FCC Class II Permissive Change Request Letter

RE: FCC Permissive II Change Request for Company: Furrion Ltd. FCC ID: 2ABH3FOC48TA-BL

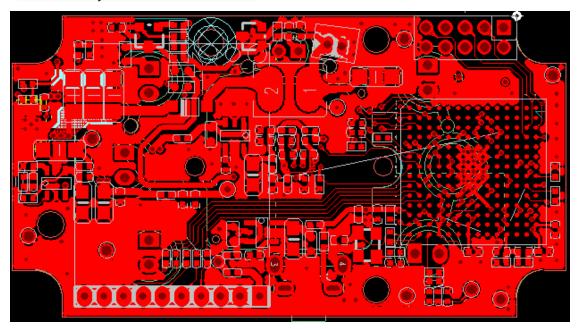
1. The RF module increase grounding cable

The TOP layer before modification

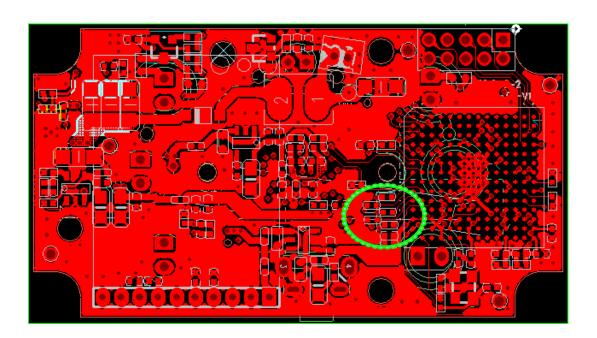
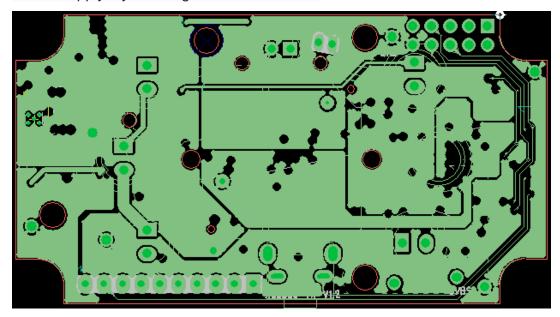
Top layer changes, magnetic beads nearer the BGA

Power supply layer changes before walk line

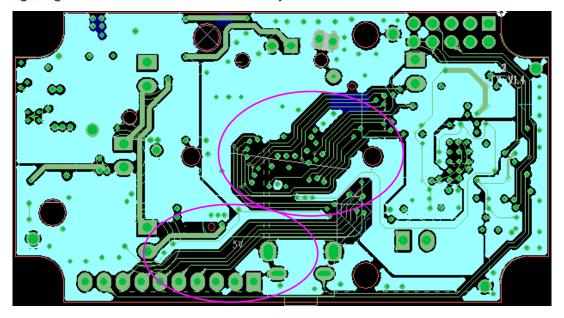
Power supply layer changes, part of the data line moved to the power supply layer, the IR lights go line also follow to do some adjustments

The underlying changes before

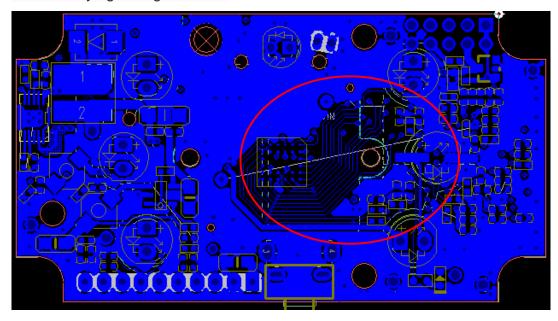
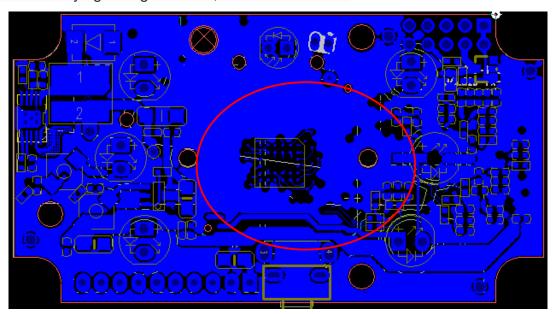
The underlying changes before, increase land area
